City of Alexandria, Virginia

MEMORANDUM

DATE: October 22, 2010
TO: Parker-Gray BAR Members
FROM: BAR Staff
SUBJECT: Comments for Conceptual Review of James Bland Park

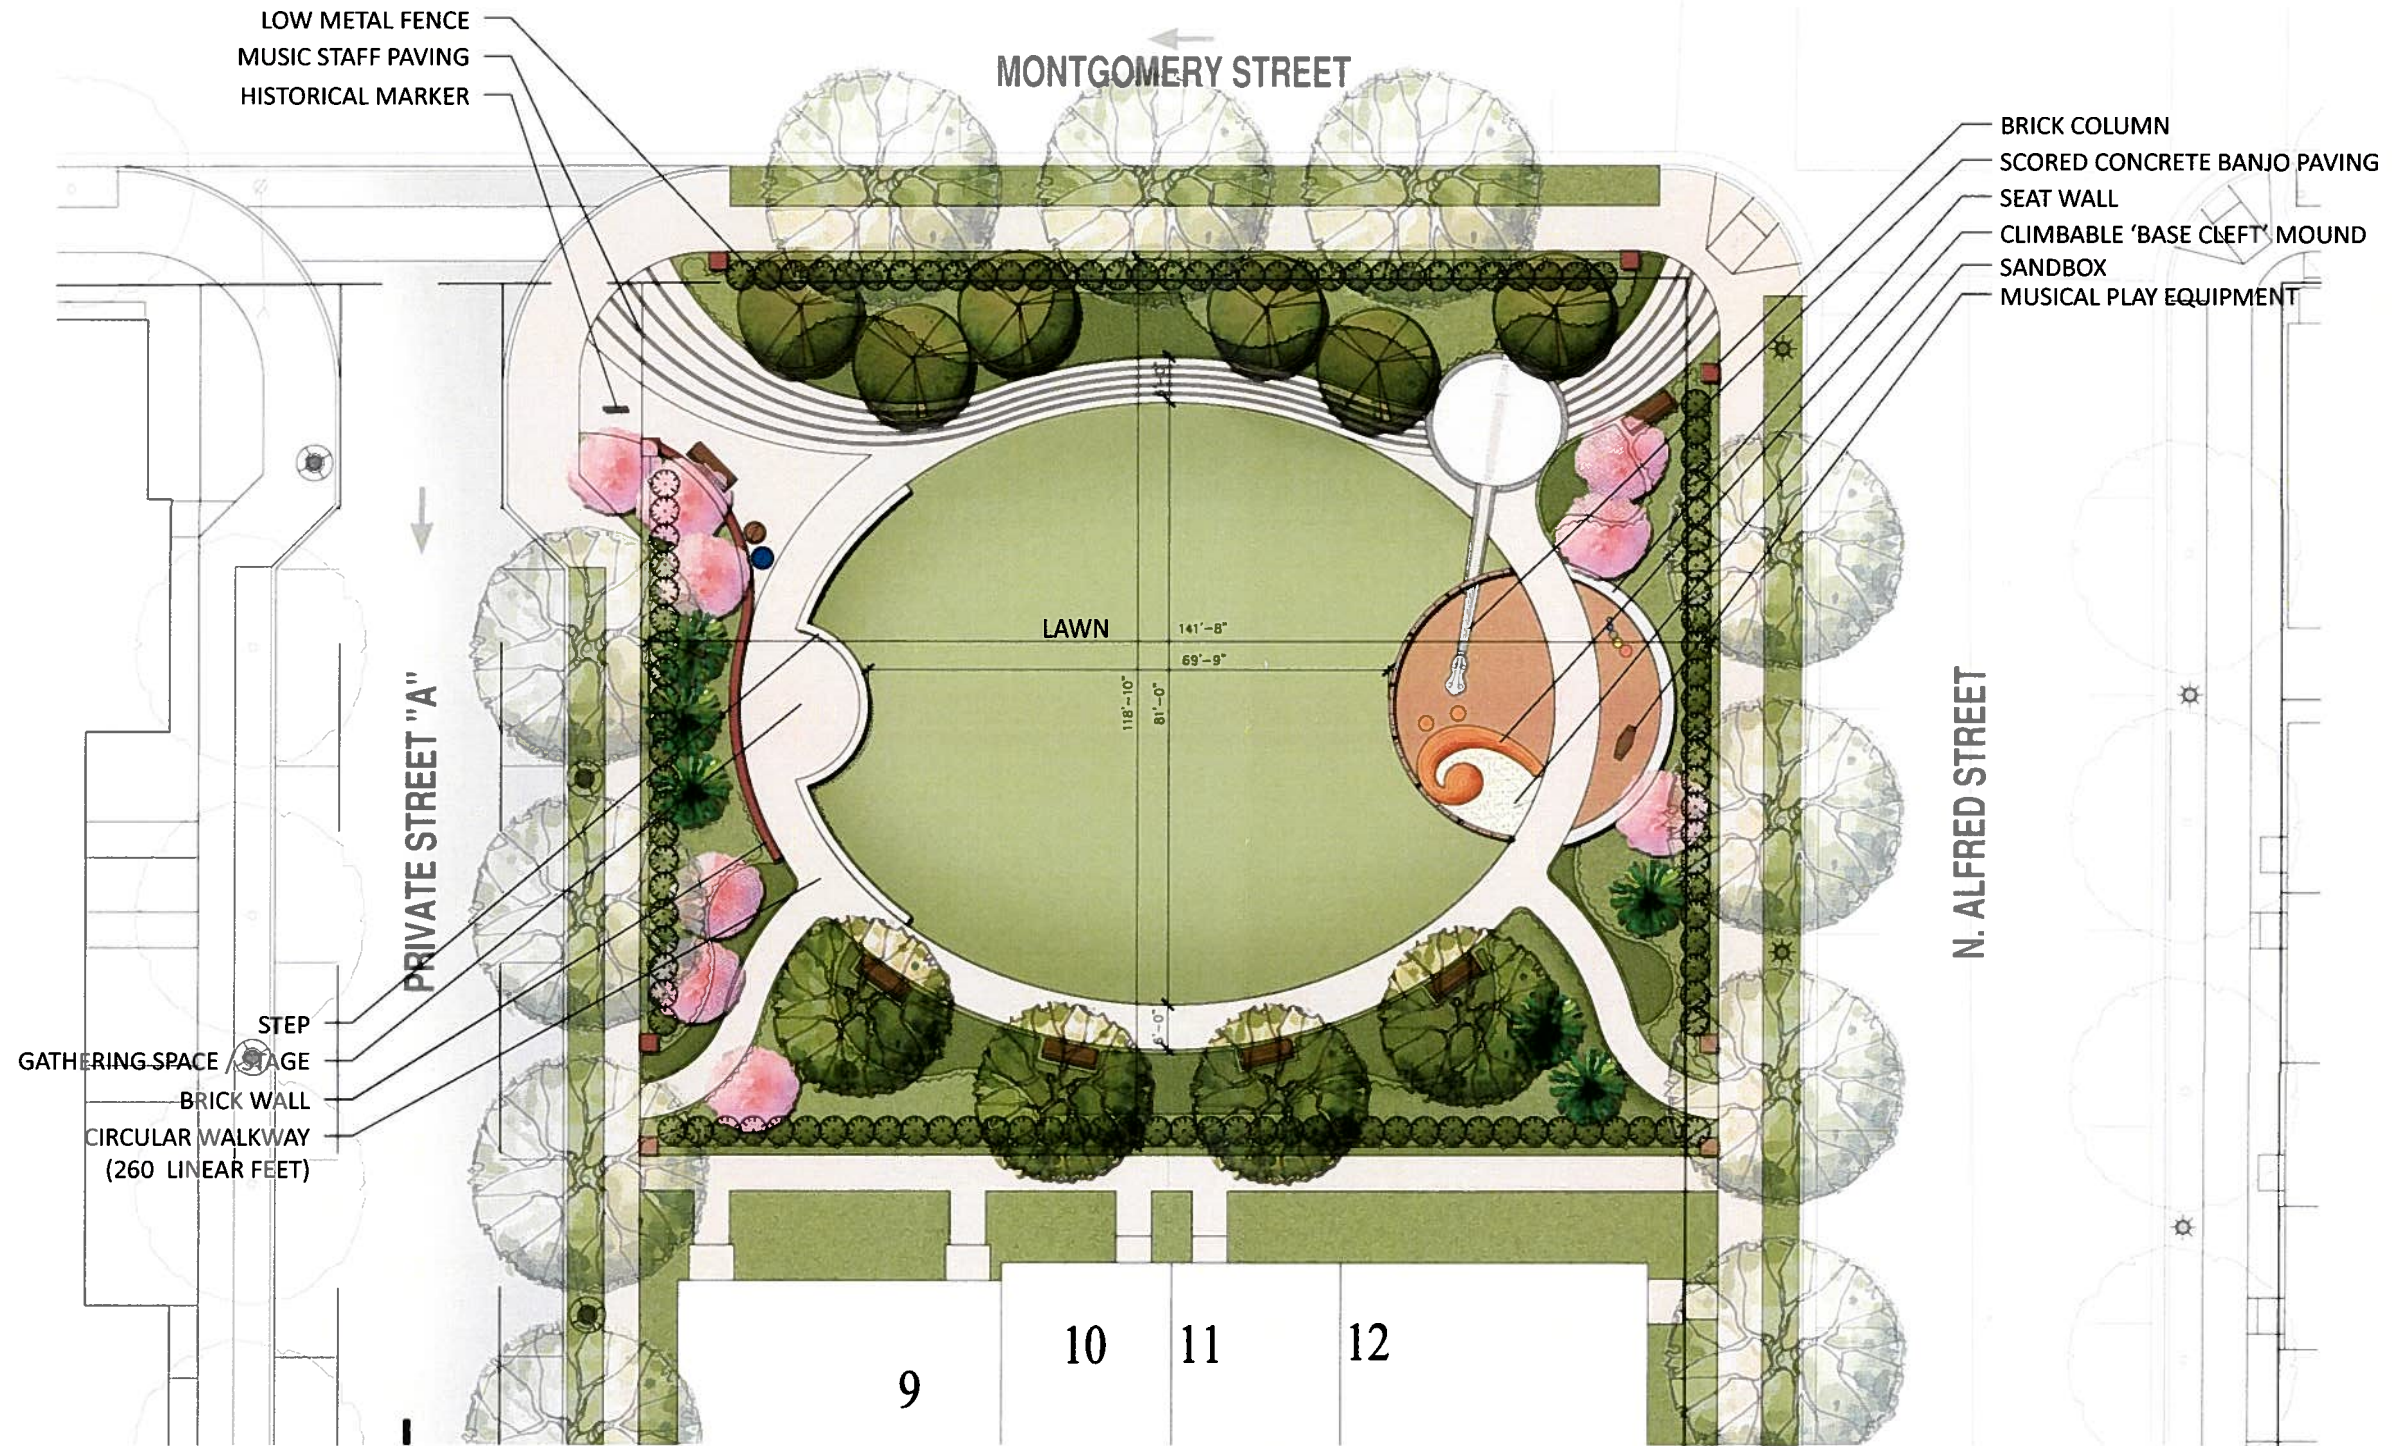
Staff supports the conceptual design of the park and believes that the choice of a musically themed park is appropriate as a reference to James Bland, a popular songwriter and musician who was noted for breaking racial barriers in the music industry.¹ Staff recommends that the applicant continue with this theme and utilize materials and designs that are compatible with the character of the Parker-Gray district and consistent with the *Design Guidelines*.
